PART TWO - HERITAGE PERMIT APPLICATION:

HERITAGE PERMIT APPLICATION FORM

CONTENTS

45 Railroad St Conservation Plan

GROUND FLOOR PLAN / 1

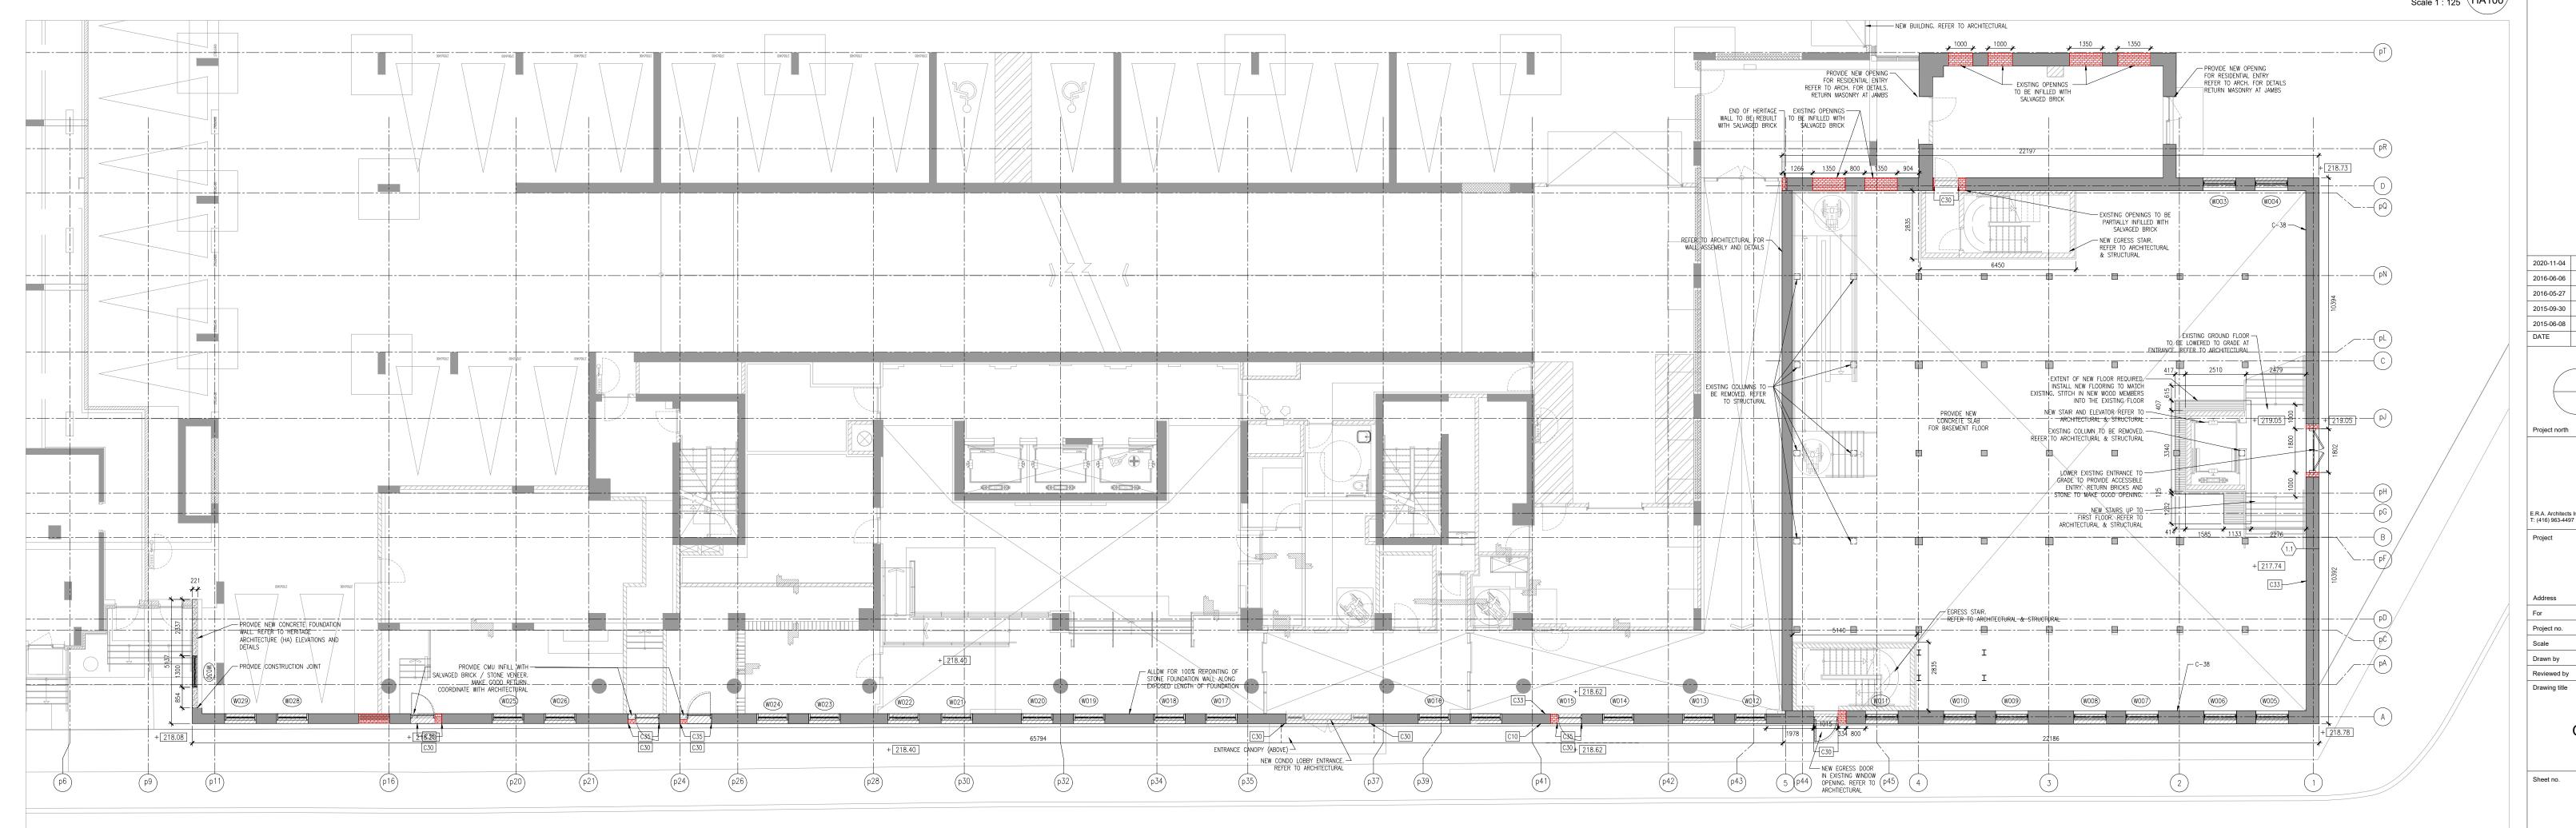
HA200 - Ground Floor Plan

WEST ELEVATION / 4 Scale NTS \HA200/

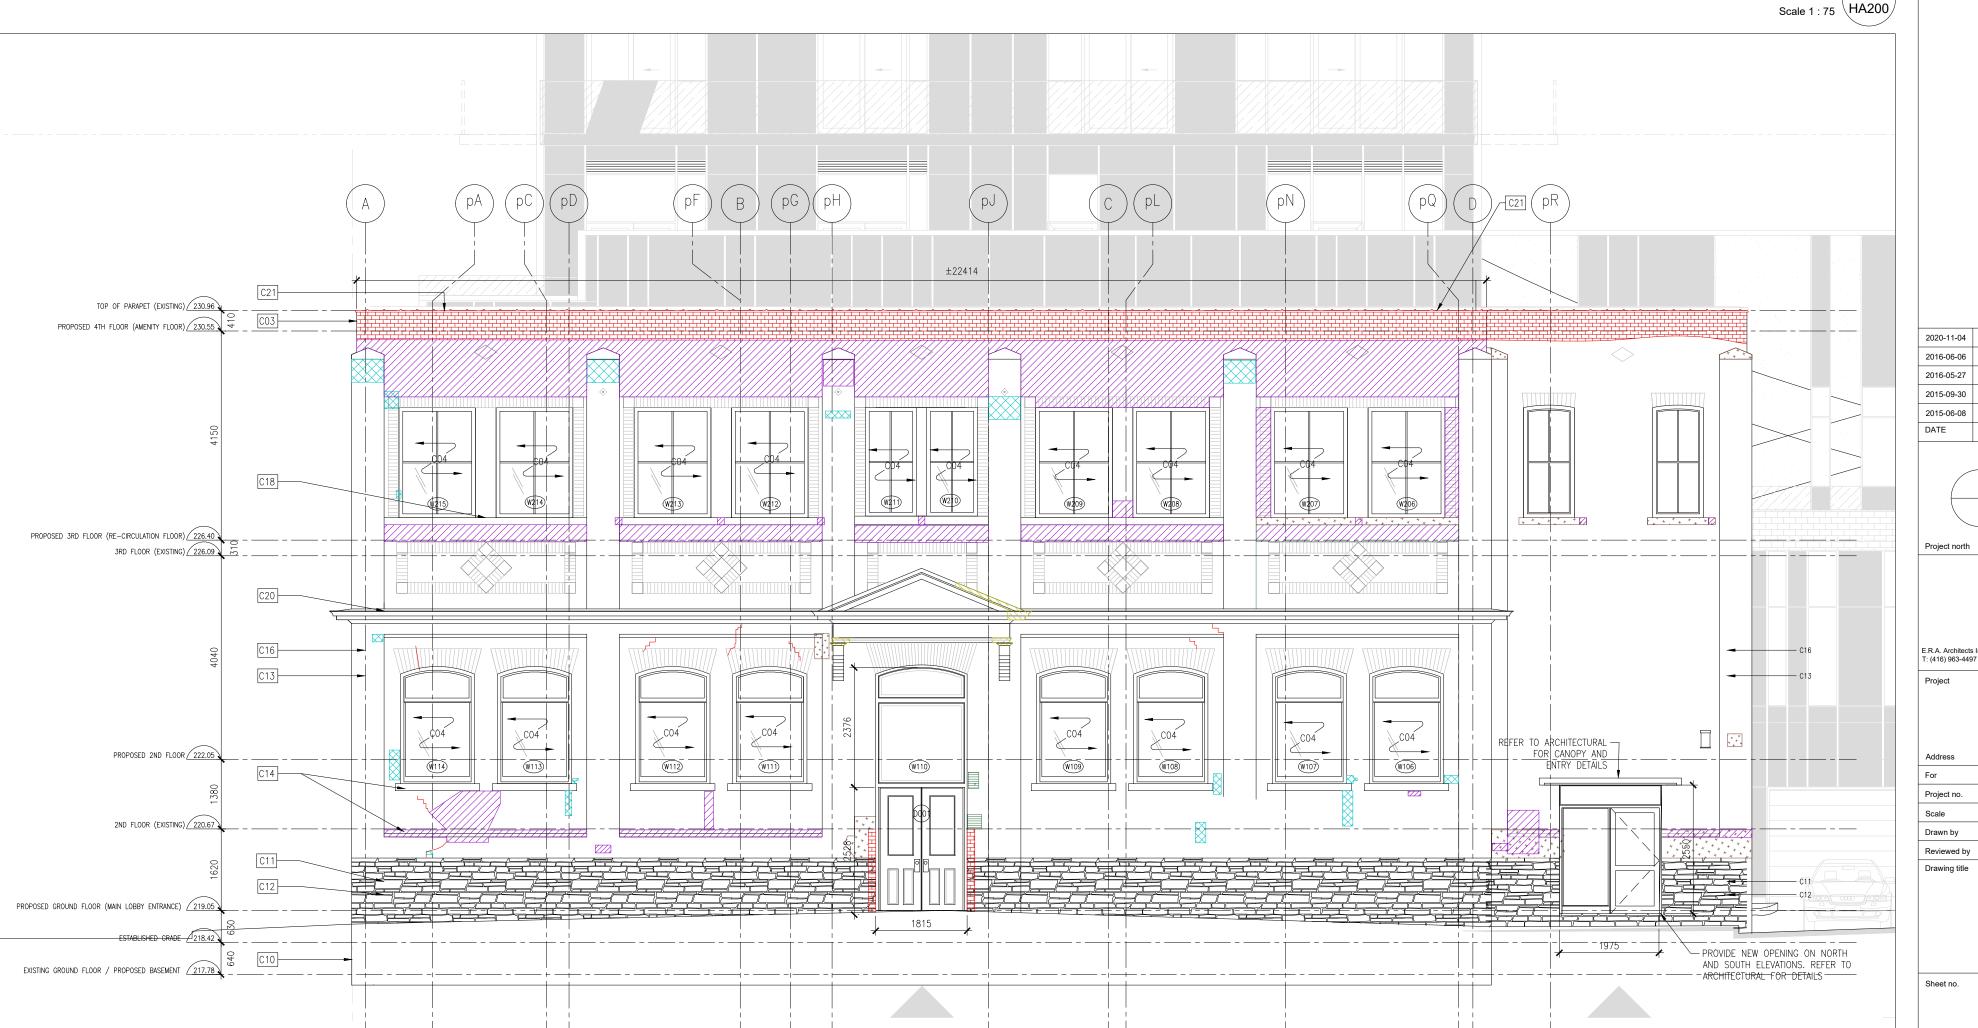
- The drawing states "restore existing windows, provide new window sashes with double glazes". Please clarify which windows (including frame and sash) are being restored, and which windows (include frame and sash) are being replaced with new units.
- In the "Heritage Conservation Notes" please specify that the replacement of original fabric/features should be in-kind, using the same material, dimensions, profile, and details.
- Specify appropriate brick cleaning approaches and mortar composition.
- · Refer to HIA comments regarding front entrance design.
- Clarify the approach being proposed for the west elevation, as the G+C drawings and ERA drawings do not correspond.
